UNITED STATES PATENT AND TRADEMARK OFFICE

APPLICATION NO.	FILING DATE	FIRST NAMED INVENTOR	ATTORNEY DOCKET NO.	CONFIRMATION NO.
10/653,889	09/04/2003	Makoto Yoshida	501.37959CC2	4939

Office Action Summary	Application No.	Applicant(s)	
	10/653,889	YOSHIDA ET AL.	
	Examiner	Art Unit	
	Hoai v. Pham	2814

DETAILED ACTION

FIG. 8

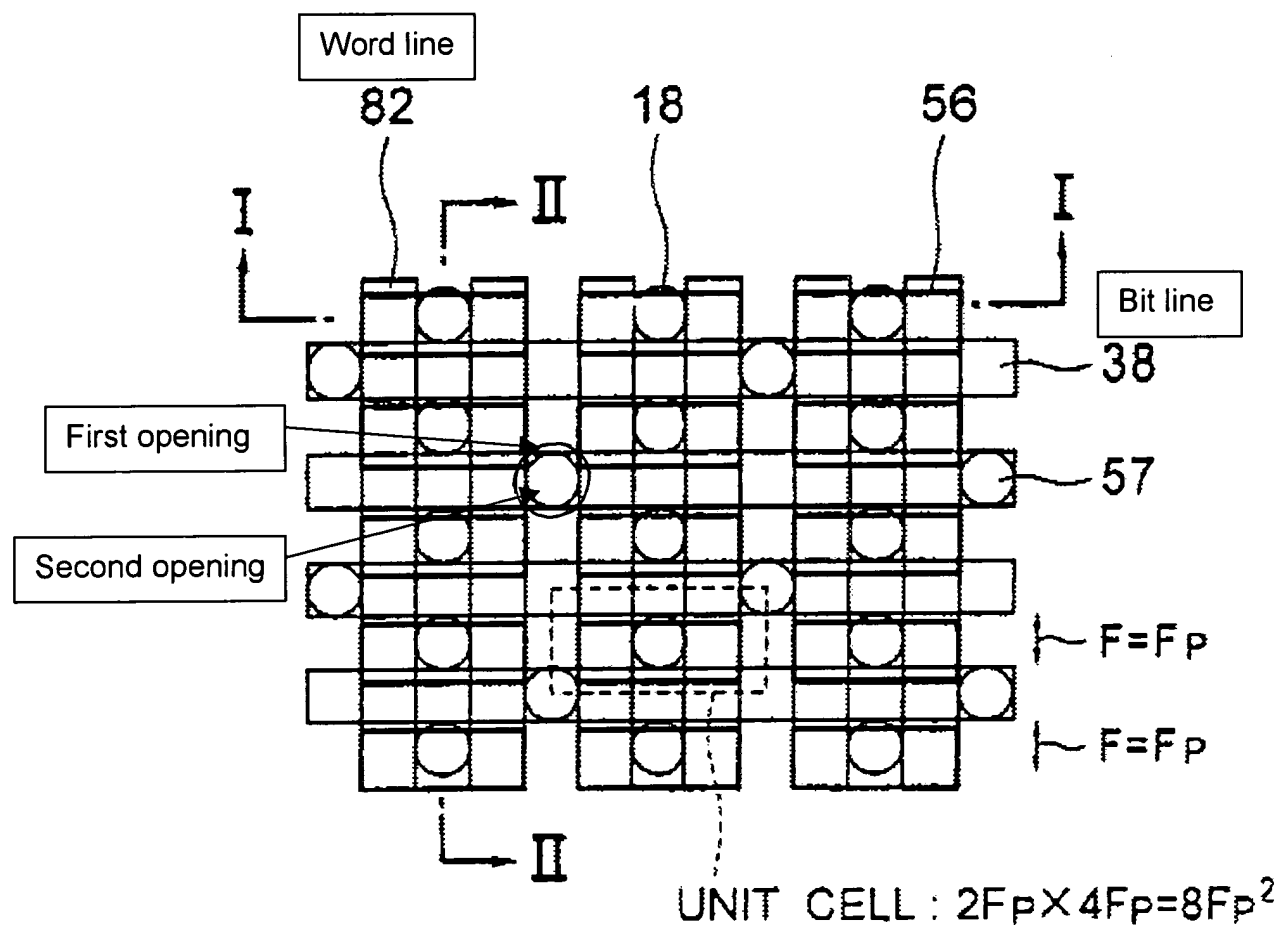
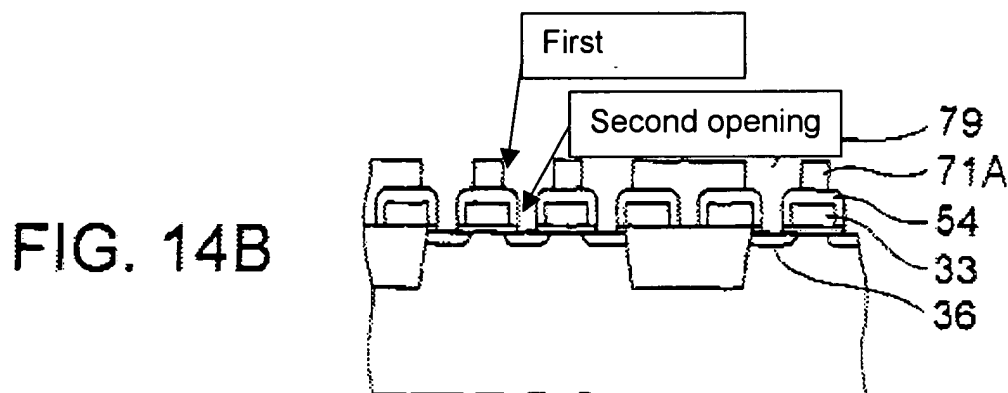
a bit line (38) formed on said first opening (79) such that said bit line is electrically coupled to said conductive material (34) and extends to cross said word lines (see fig. 8).

a bit line (38) formed on said first opening (79) such that said bit line is electrically coupled to said conductive material (34) and extends to cross said word lines (see fig. 8).

a bit line (38) formed on said first opening (79) such that said bit line is electrically coupled to said conductive material (34) and extends to cross said word lines (see fig. 8).

opening and such that said second opening reaches said semiconductor regions (fig. 14B); and a bit line (38) formed on said first opening (79) which is formed on said second insulating film (54) such that said bit line is electrically coupled to said conductive material (34) and extends to cross said word lines (see fig. 8).
